Request for Proposal (RFP)  
 Bid No: Bid 26-05-4136SB  
 Addendum No. 3

**Date:** June 19, 2026  
**To:** All Proposers  
**Subject:** Addendum No. 3  
 Consisting of Seventeen (17) Pages  
**RFP No.:** Bid 26-05-4136SB  
**Project Name:** N9073(1)1,2&4 Blue Canyon Road Project in Apache County, AZ  
**Owner:** Navajo Division of Transportation

## Addendum No. 3

REVISION	BY	DATE
NAVAJO NATION DIVISION OF TRANSPORTATION N90072(1) 1, 2&3		
<b>WATERLINE RELOCATION</b>		
PROJECT MANAGER: MLL	DATE: 4/26	DRAWING
LEAD DESIGNER: RW	DATE: 4/26	SHEET
ASBUILT BY:	DATE:	22X34 79

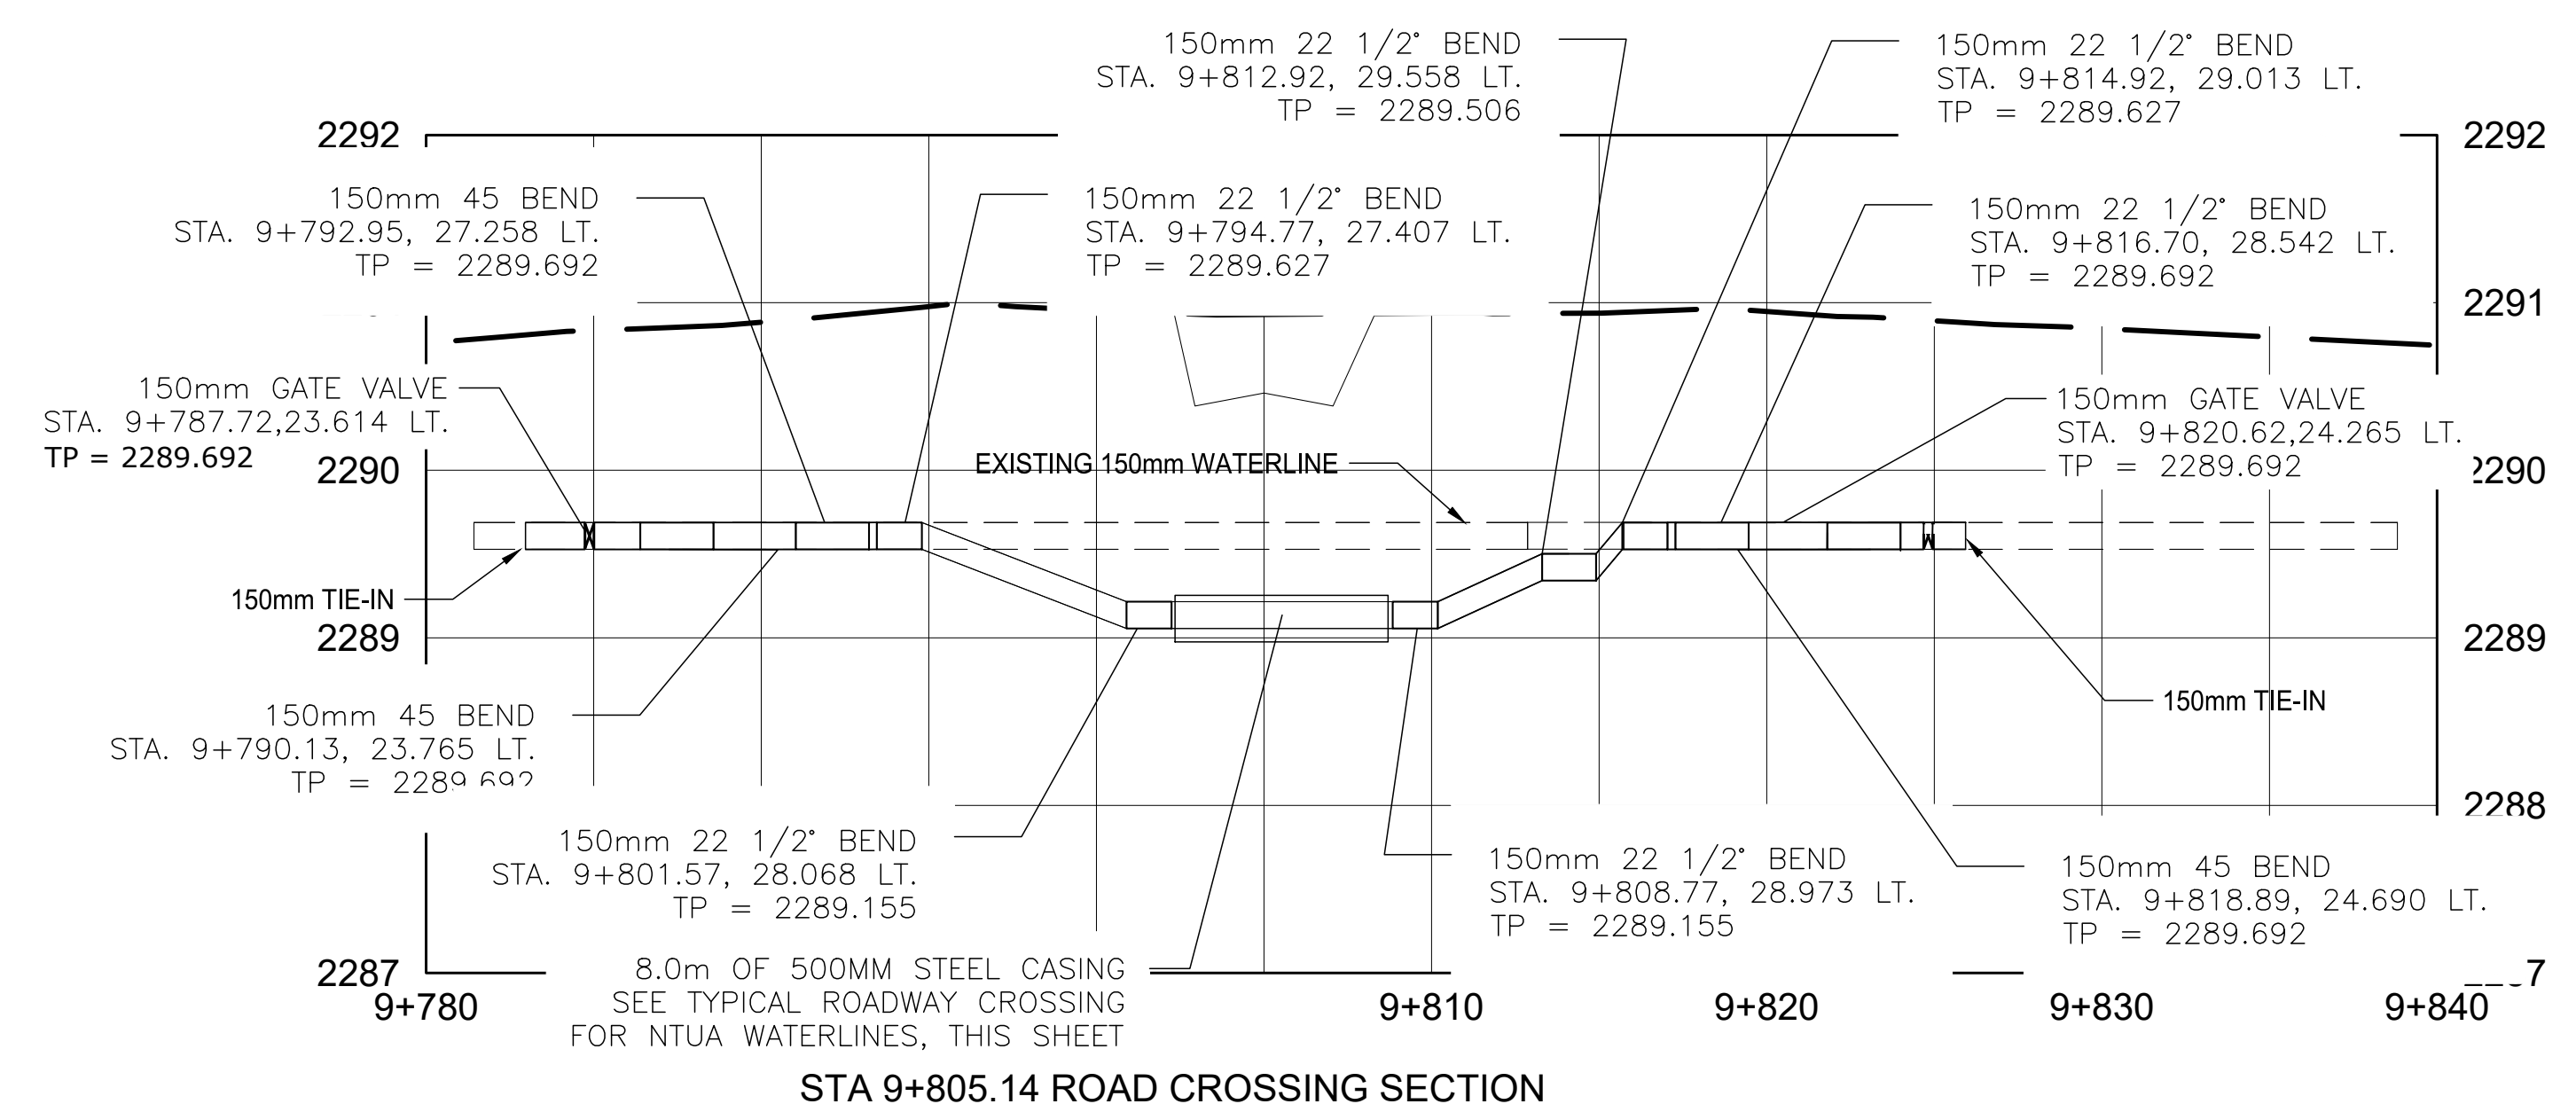
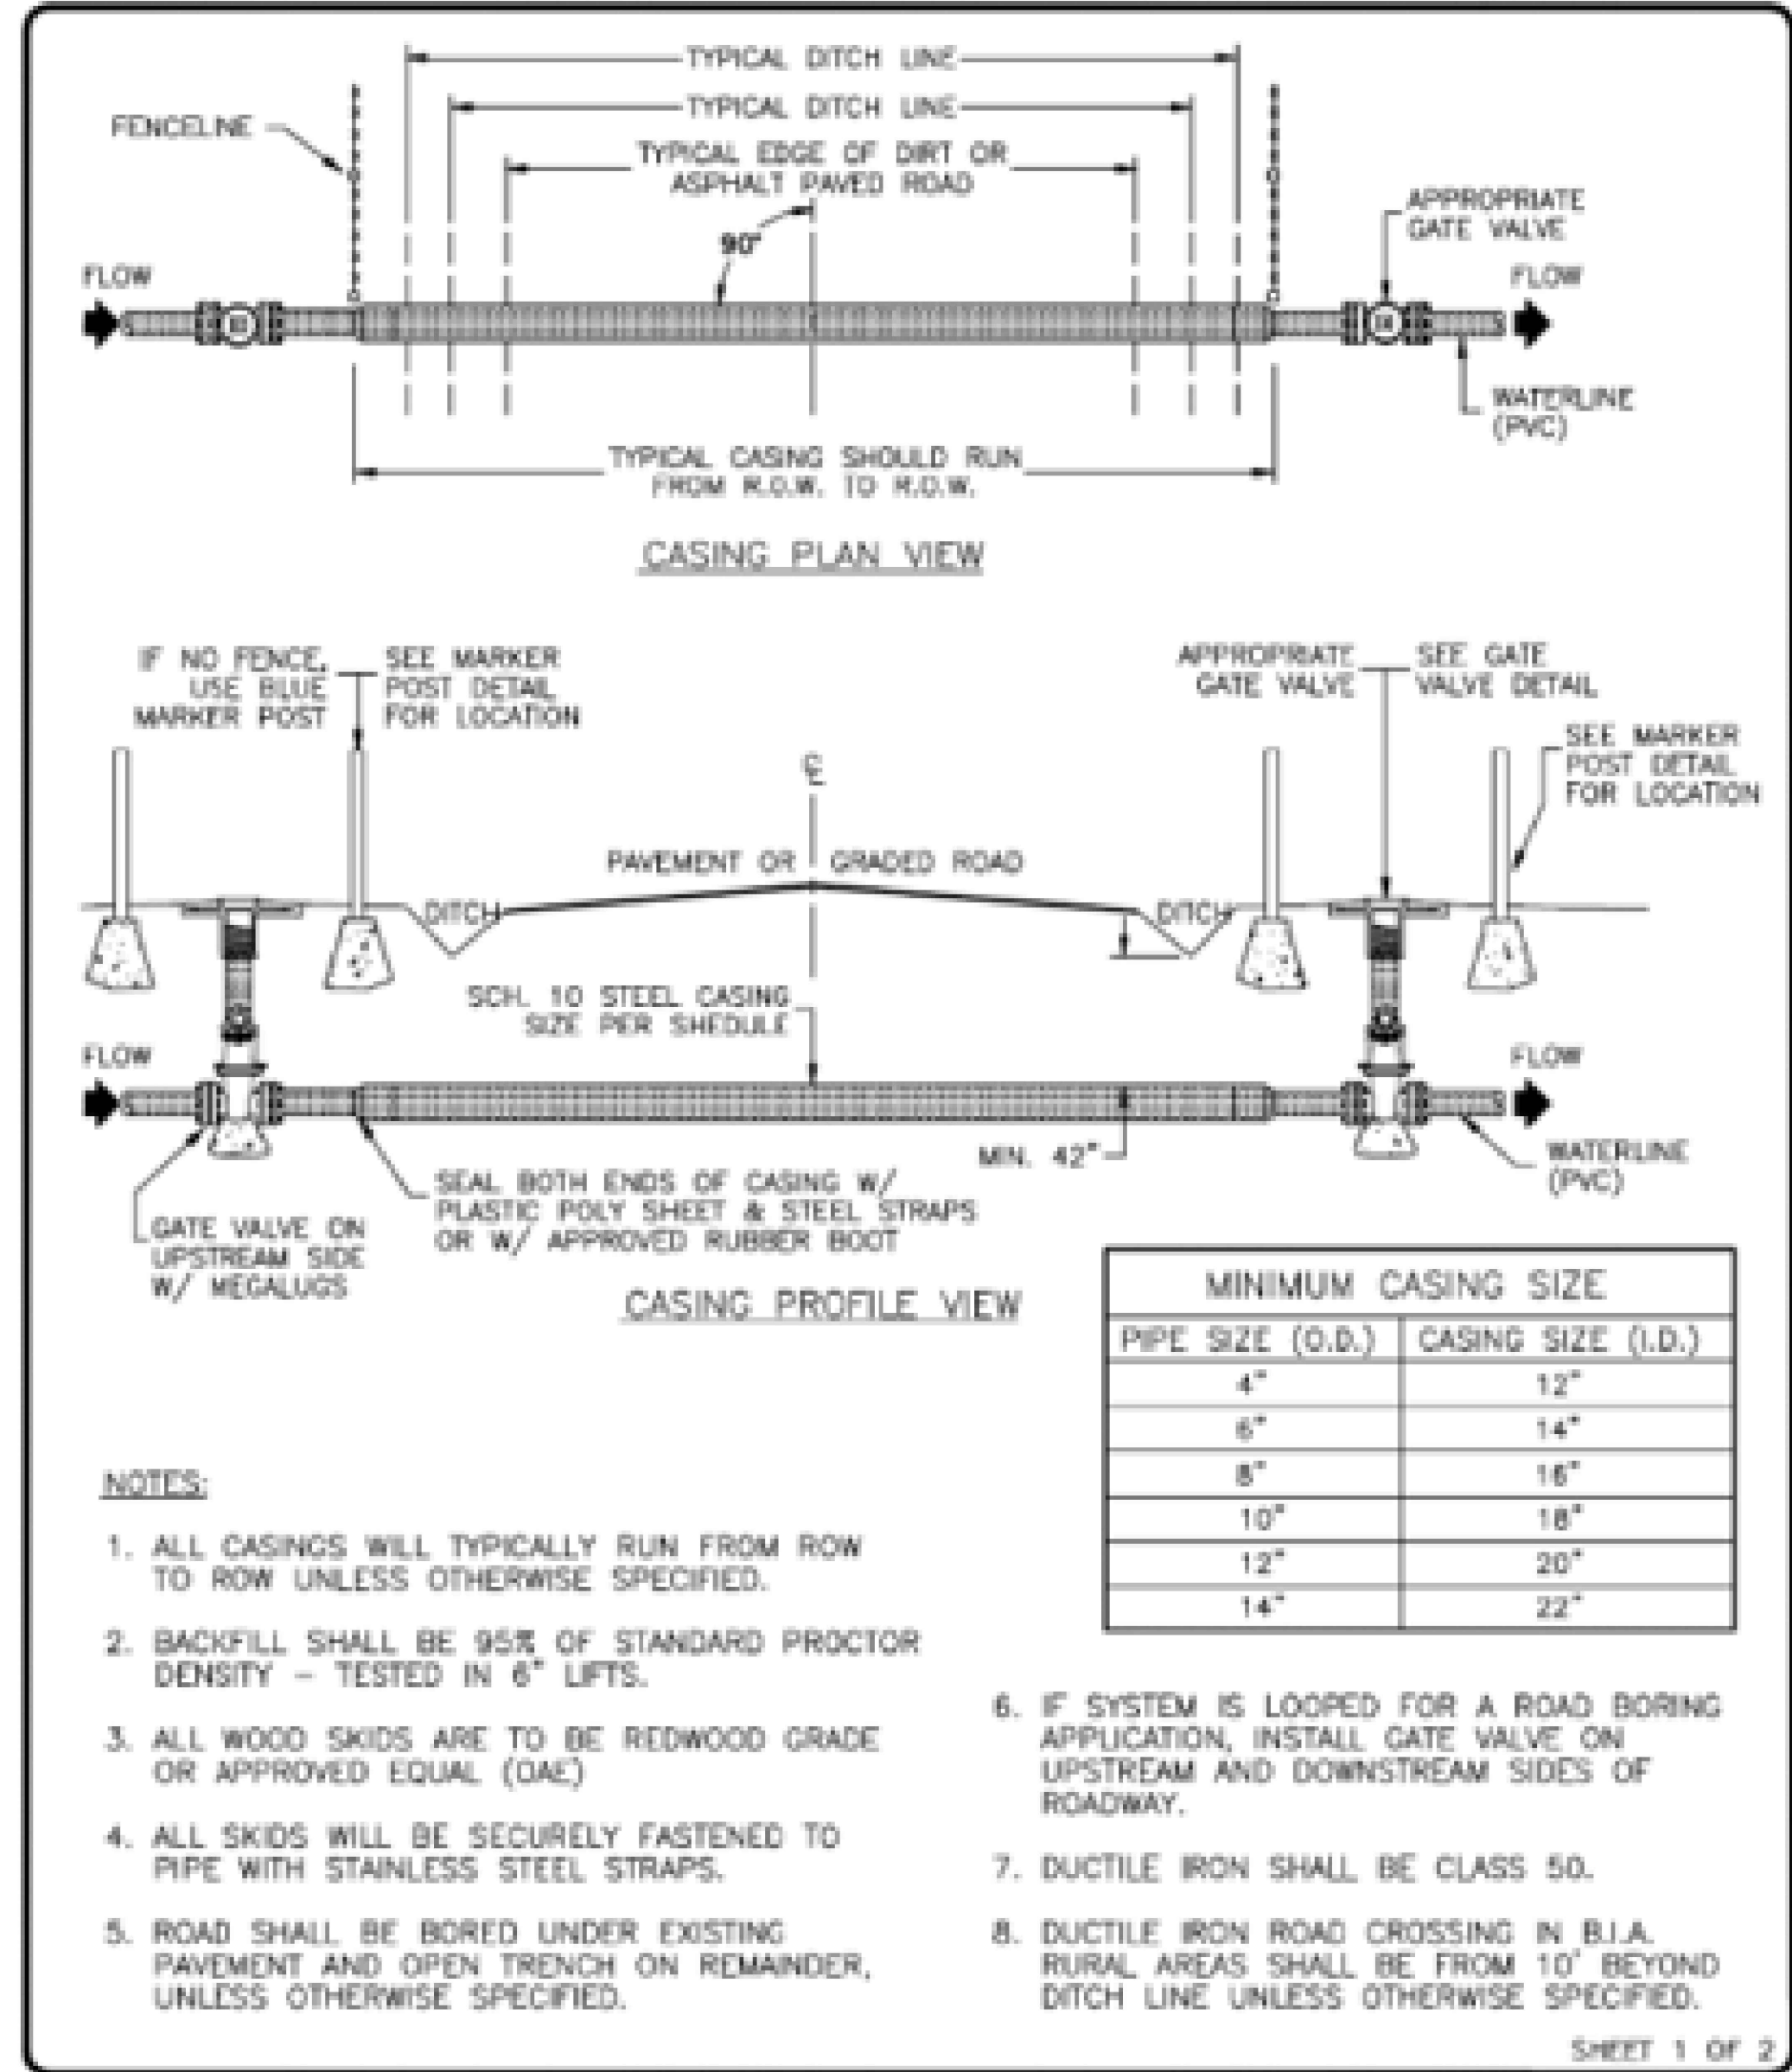
- The overall plans are being reviewed, and design revisions to the earthwork are being implemented. These implementations will be in a forthcoming addendum #4.
- Sheet 7 ESTIMATED QUANTITIES TABLES:
  - Revised to update the quantity for Bid Item No. 25302-100 Gabions, Aluminized Coated, Class 2 to 9,335 m<sup>3</sup>.
  - Revised for the updated NTUA waterline relocation design.
- Sheet 33A: Revised to update the quantity for Bid Item No. 25302-100 Gabions, Aluminized Coated, Class 2 to 9,335 m<sup>3</sup>, removing segment 2.
- Sheets 77-80: Revised for the updated NTUA waterline relocation design.
